Access Compliance Report

Public Rights-of-Way

(Curb Ramps)

Intersection ID: 16141	Main Street: N_WENDOVER_RD	Cross Street: LATROBE_DR	Location: NW
ADA ID: A5004ACA78FF	Ramp Type: MedianPerp	Initial Pass/Fail: Fail	Overall Compliance: No
Severity Score: 22.5			
Codes/Mitigation Info/Possible Solution		Field Measurements/Component Compliance

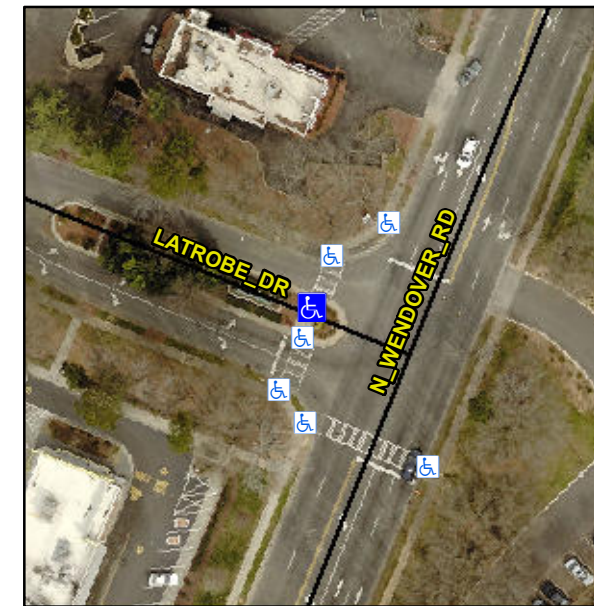
Not Found, R304.5.1, R304.2.2, R304.5.3

Compliance	Description	Data	Compliance	Description	Data
N/A	Ramp Length (in)	72.0	No	Ramp Slope (%)	10.7
No	Ramp Width (in)	45.0	No	Ramp XSlope (%)	3.5
N/A	Flare Type LT	N/A	N/A	Flare Type RT	N/A
N/A	Flare Slope LT (%)	N/A	N/A	Flare Slope RT (%)	N/A
N/A	Flare Traversable LT?	N/A	N/A	Flare Traversable RT?	N/A
N/A	Landing Length (in)	N/A	N/A	DWS Provided?	N/A
N/A	Landing Width (in)	N/A	N/A	DWS Contrast?	N/A
N/A	Landing Slope (%)	N/A	N/A	DWS Length (in)	N/A
N/A	Landing X Slope (%)	N/A	N/A	DWS Full Width?	N/A
N/A	Landing Curb? (Y/N)	N/A	N/A	DWS Offset (in)	N/A
N/A	Shared Landing?	N/A			
N/A	Gutter Ponding?	N/A	N/A	Gutter Slope (%)	N/A
N/A	Gutter Lip Ht (in)	N/A	N/A	Gutter X Slope (%)	N/A
N/A	Painted X Walk1?	Yes	N/A	Painted X Walk2?	N/A
	X Walk 1 Direction	To NE		X Walk 2 Direction	N/A
N/A	X Walk 1 Width (in)	110.0	N/A	X Walk 2 Width (in)	N/A
	X Walk 1 Slope (%)	7.3		X Walk 2 Slope (%)	N/A
	X Walk 1 X Slope (%)	2.6		X Walk 2 X Slope (%)	N/A

Remove & Replace Entire Ramp.
